Technical Warning

TCK4S/TCK4NGS

Essential Fitting Information

TB0063

Old Sintered Design

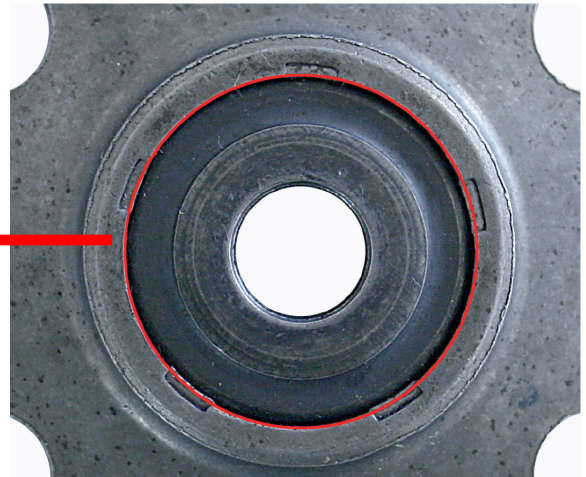
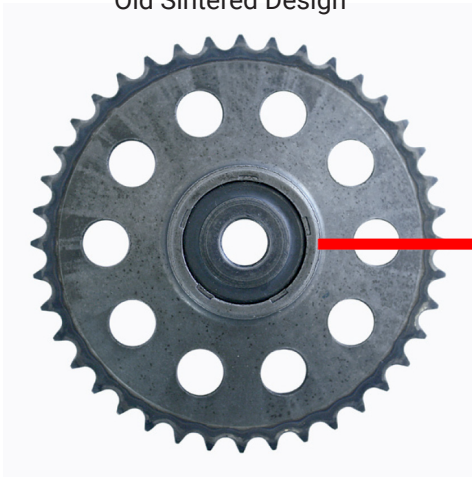
The original GM timing gears for this engine up to engine number 19DN0327 were made from sintered material and included a built in spacer/washer. Later engines used pressed steel gears which did not require the spacer/washer. GM have stopped production of the early gears and now only offer the later pressed steel gears which can be found in this FAI kit.

Important: Sintered and pressed steel gears must NOT be mixed.

When replacing the old design gear for the new pressed steel design. You will need to assemble the new components as shown in the diagram.

NB: Be sure to fit the spacer/washer with the flat surface forward (touching the pickup trigger plate).
